ADDENDUM NO. 1
TO THE
CONTRACT DOCUMENTS
FOR
PROJECT NO. 20WA17
24-INCH TRANSMISSION MAIN
HOOKER ROAD TO ISABELL AVENUE
FOR
CITY OF ROSEBURG

ISSUED THIS 26TH DAY OF MAY, 2021.

ITEM NO. 7 – VOLUME 2; DRAWINGS

CONNECTION DETAILS - 1

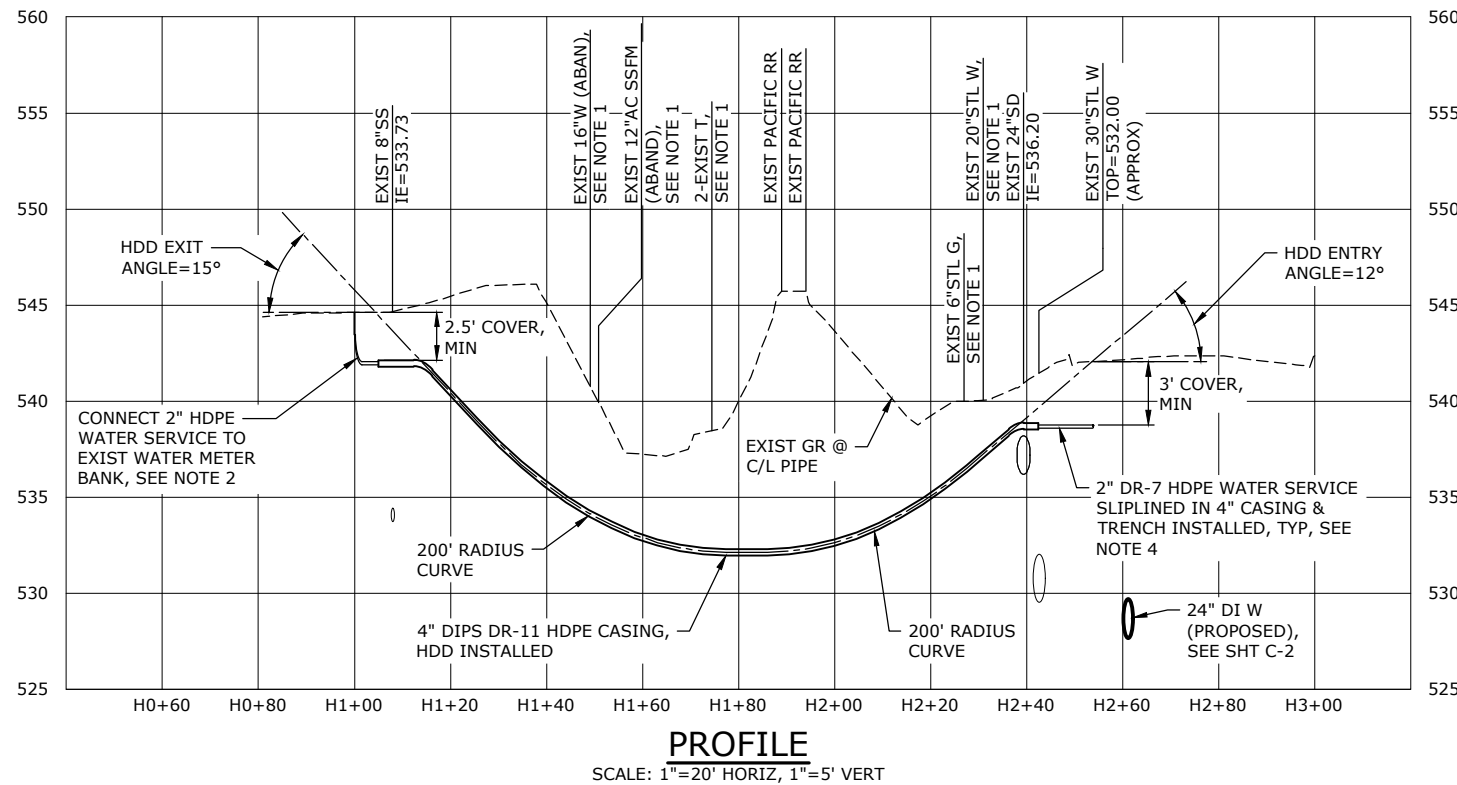
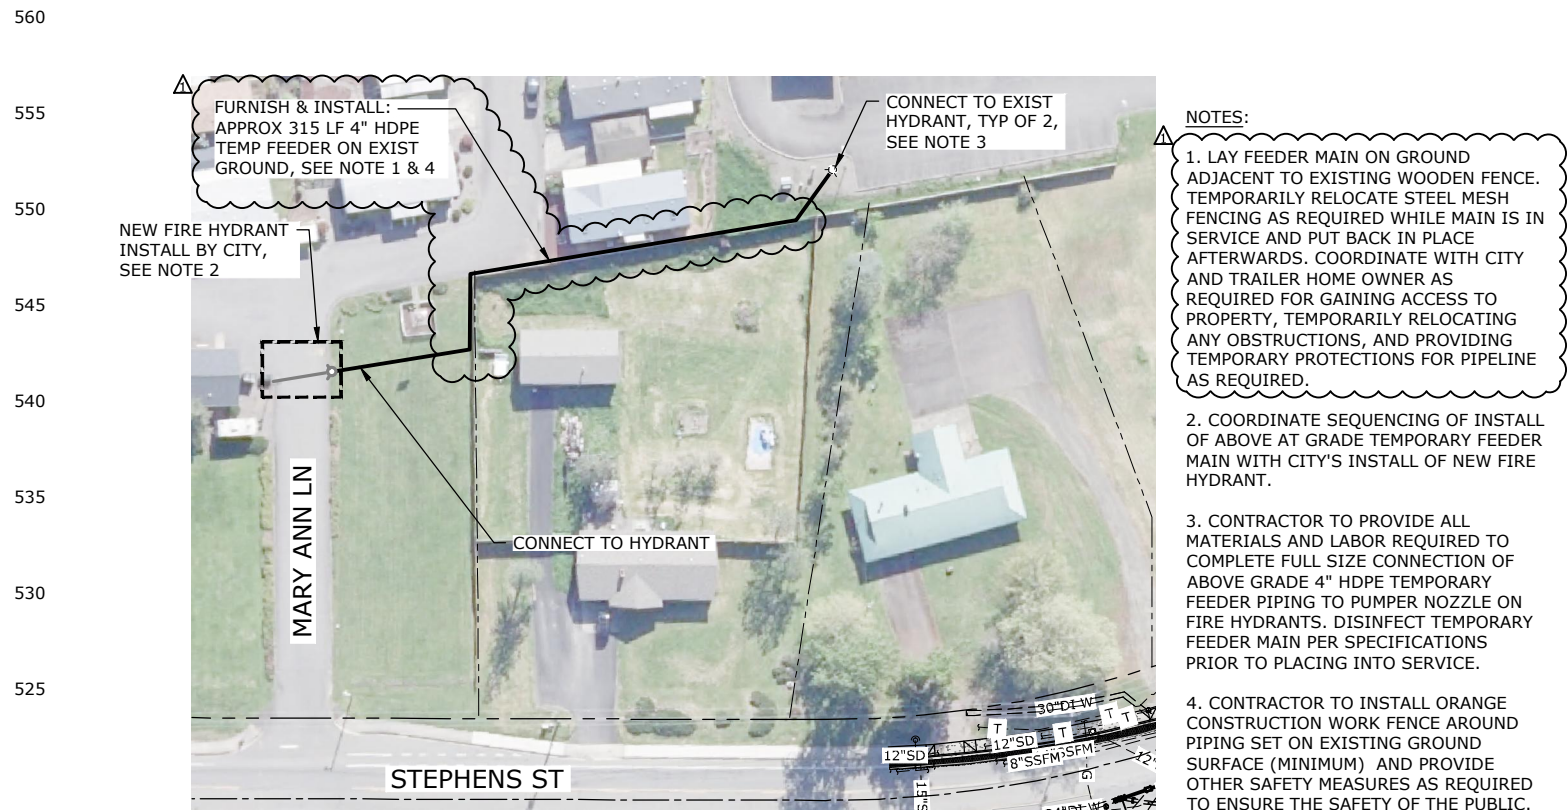
- A. **REPLACE** Sheet C-8, CONNECTION DETAILS – 1 (17 OF 31), **WITH** the attached updated sheet.
